TITLE INCREASE STABILITY OF PHASE LOCK LOOP (DIABLO)				PIB NO. DK3055
PRODUCT LINE:	TAPE DISK FORMATTER [] [X] []	EQUIPMENT CHANGED Logic PCBA (see below)	MODEL SERIES AFFECTED D3000	EFFECTIVE DATE May 31, 1976

TITLE INCREASE STABILITY OF PHASE LOCK LOOP (DIABLO)

PIB NO.
DK3055

FIGURE 1

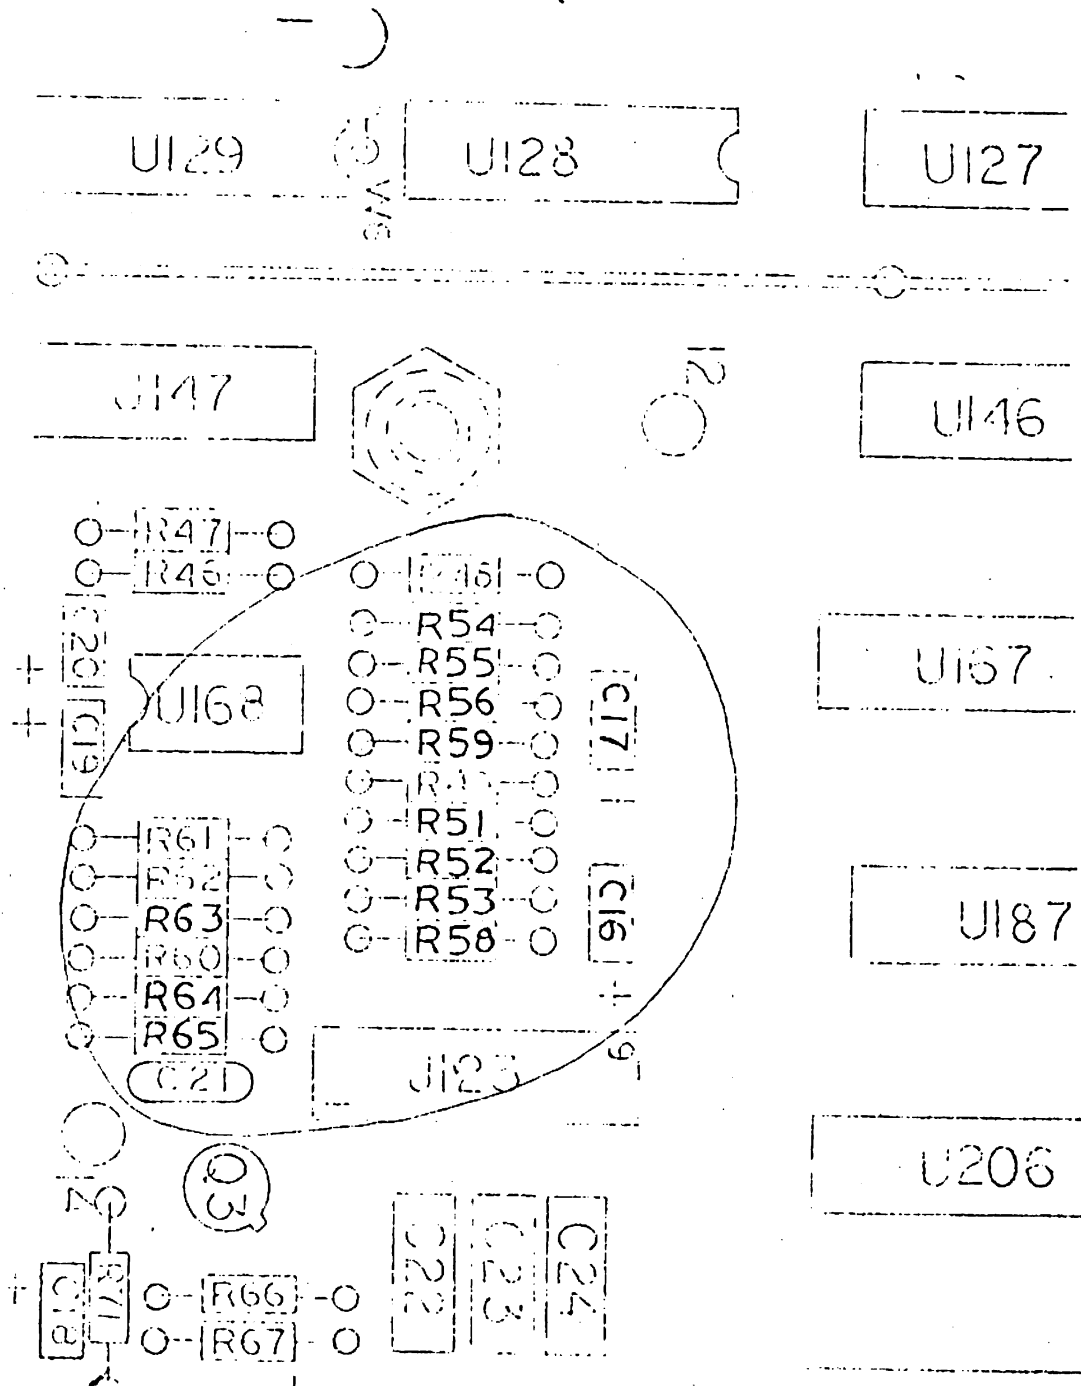
1. Locate components on PCBA (Zone C6 on 103705 schematic) R54,55,56,59,51,52,53,58 65 and C16,17. (See Figure 1).
2. Remove R54 and install 2.7K resistor.
3. Remove R55 and install 10K resistor.
4. Remove R56 and install 6.8K resistor.
5. Remove R59 and install 1K resistor.
6. Remove R51 and install 2.7K resistor.
7. Remove R52 and install 10K resistor.
8. Remove R53 and install 6.8K resistor.
9. Remove R58 and install 1K resistor.
10. Remove R65 and install 3.3K resistor.
11. Remove C17 and install 10 MFD capacitor.
12. Remove C16 and install 10 MFD capacitor.
13. Locate R63 and R64.
14. Note Figure 2 for piggyback installation drawing.
15. Install C79 (.015 UF capacitor) piggyback on R64 as shown in Figure 2.
16. Install C80 (.015 UF capacitor) piggyback on R63 as shown in Figure 2.

FIGURE 2

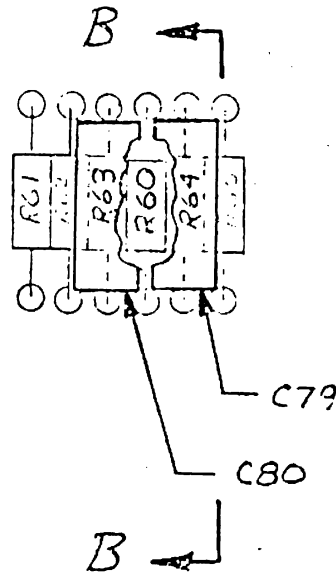
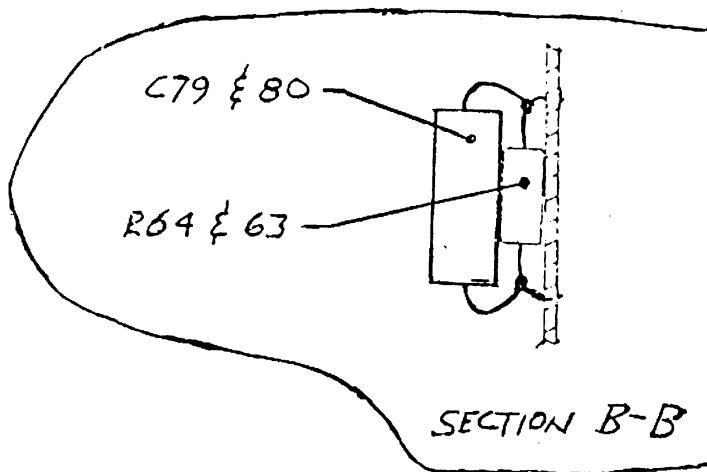
Solder C79 and C80

Piggyback as shown to

R64 and 63 respectively.

FIGURE 3.

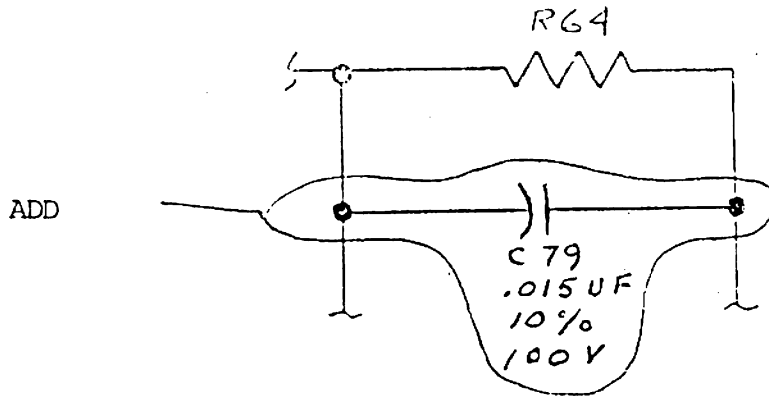
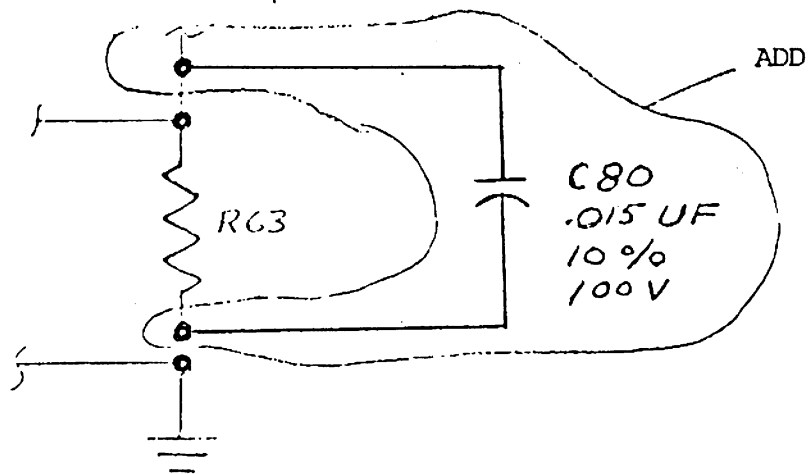
1. On sheet 5 of schematic add capacitors as shown in Figure 3.
2. On sheet 5 of schematic make changes as listed in Table 1.
3. On sheet 1, zone C17 under Reference Designations, last used change C78 to C80.
4. On sheet 1, zone D18, Table 1, add

Zone B/19, R56	FROM: 2.7K	TO: 6.8K
Zone B/19, R55	FROM: 6.8K	TO: 10K
Zone C/19, R54	FROM: 3.9K	TO: 2.7K
Zone C/19, R53	FROM: 2.7K	TO: 6.8K
Zone C/19, R52	FROM: 6.8K	TO: 10K
Zone D/19, R51	FROM: 3.9K	TO: 2.7K
Zone C/18, C16	FROM: 22 uf 20%, 6V	TO: 10 uf 20%, 6V
Zone C/18, R58	FROM: 330	TO: 1K
Zone B/18, R59	FROM: 330	TO: 1K
Zone B/18, C17	FROM: 22 uf 20%, 6V	TO: 10 uf 20%, 10V
Zone B/17, R65	FROM: 4.7K	TO: 3.3K
